ICP Transport Projects Cost Estimate Review  
Expert Witness Report

## Sunbury South and Lancefield Road ICP

Reference No. 1700E  
Prepared for Best Hooper Lawyers  
14 October 2020

Fig 2 – Combined plan showing SS-IN-08 and LR-IN-01

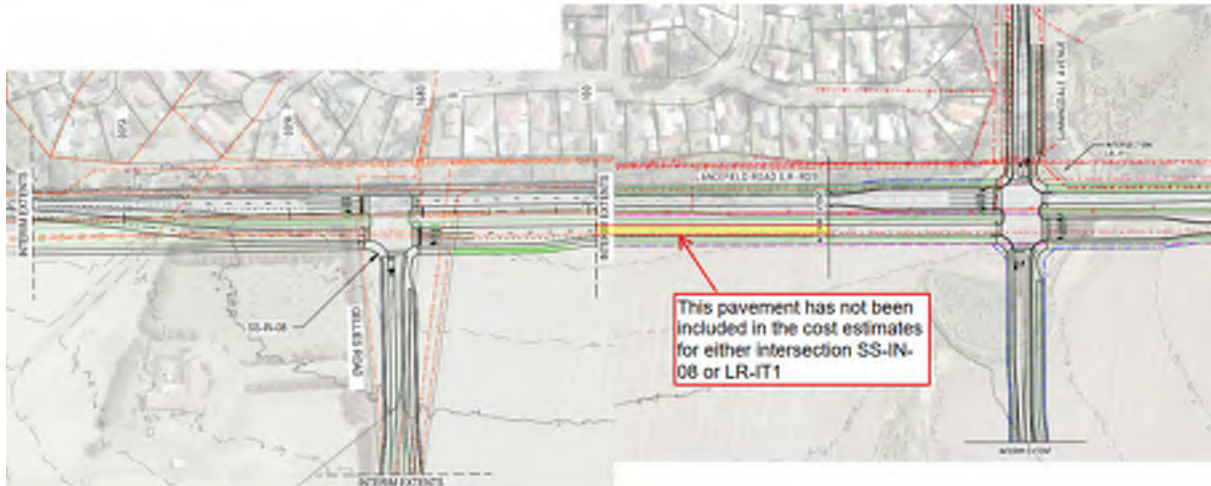
There is currently a funding gap for the section of road works shown between the extents of the Gellies Road intersection (SS-IN-08) and the Sunningdale Avenue intersection (LR-IN-01), as demonstrated in the image below.

Figure 3 - Traffic Group concept plan of LR-IN-01 showing proposed transition on southern leg

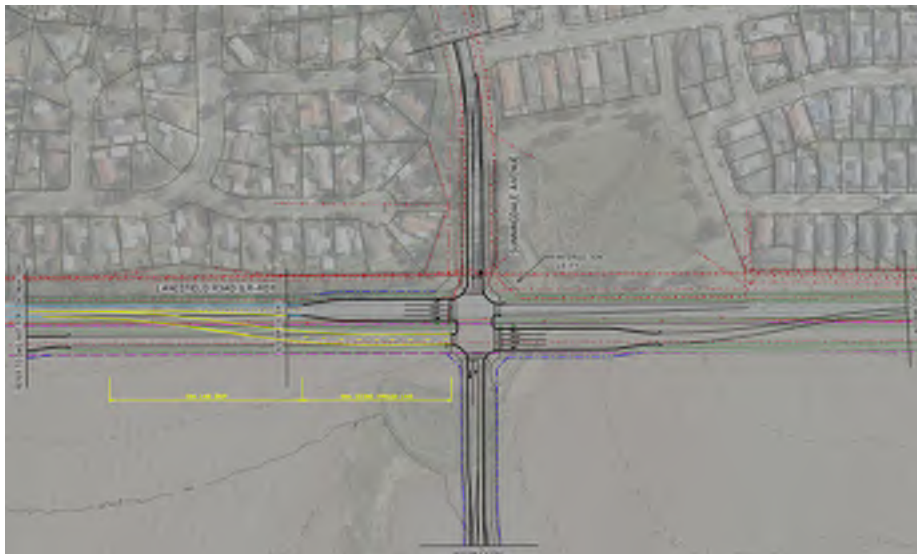
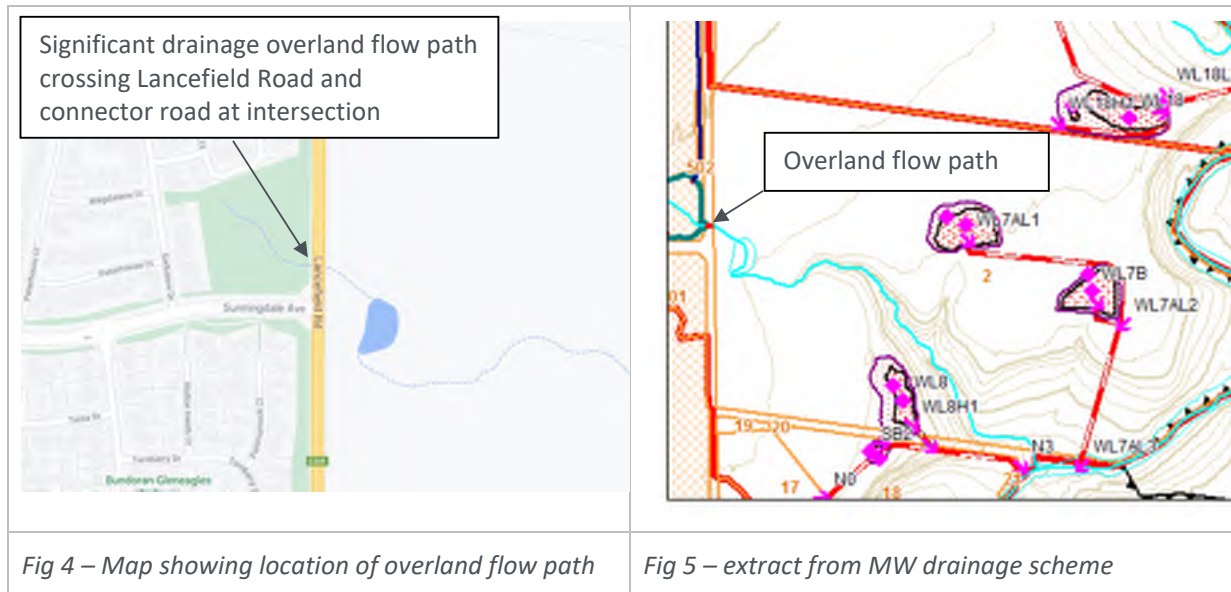
All of the intersections along Lancefield Road have transitions back to the existing carriageway, with the exception of the southern leg of LR-IN-01. Given that the timing of the intersection will be such that LR-IN-01 will be constructed before the Gellies Road intersection will be constructed (as noted in the ICP where LR-IN-01 is indicated to be a short to medium term project, whereas SS-IN-08 is indicated to be a medium to long term project) a transition back to the existing carriageway on the eastern carriageway of Lancefield Road (southern leg) will be required. This will require the extent of the interim intersection for LR-IN-01 to be moved further south as shown in the concept plan below.

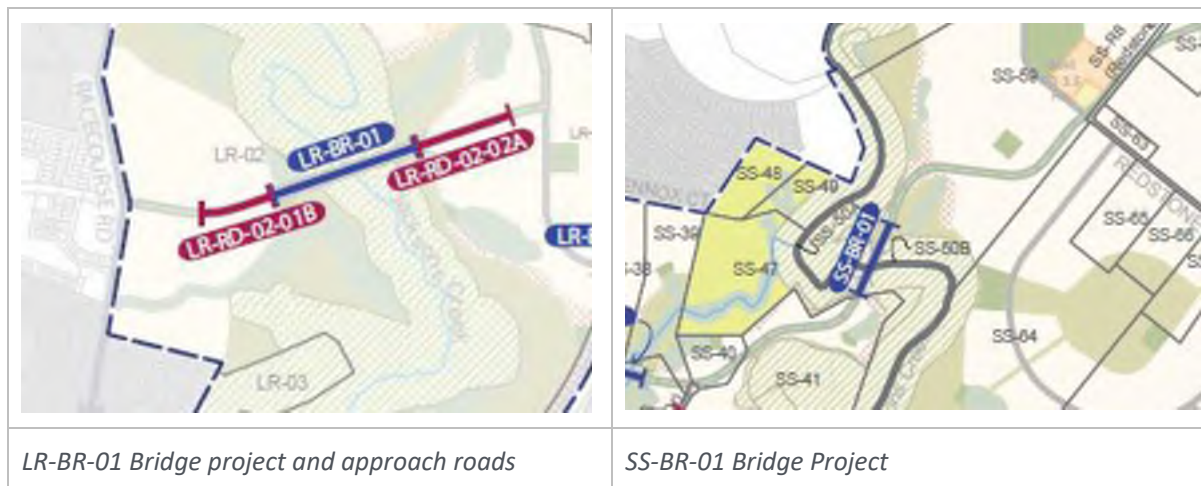
The ICP cost estimate has made an assumption in relation to the amount of cut at each intersection, which is based on the Council Standard drawing SD 06 indicating a pavement depth of 685mm, which as discussed above is not appropriate for arterial roads. The amount of cut allowed in the cost estimates should be based on an arterial road pavement composition, which T&T have calculated to be 770mm (12% increase in pavement depth will result in cut volumes 12% higher than currently allowed).
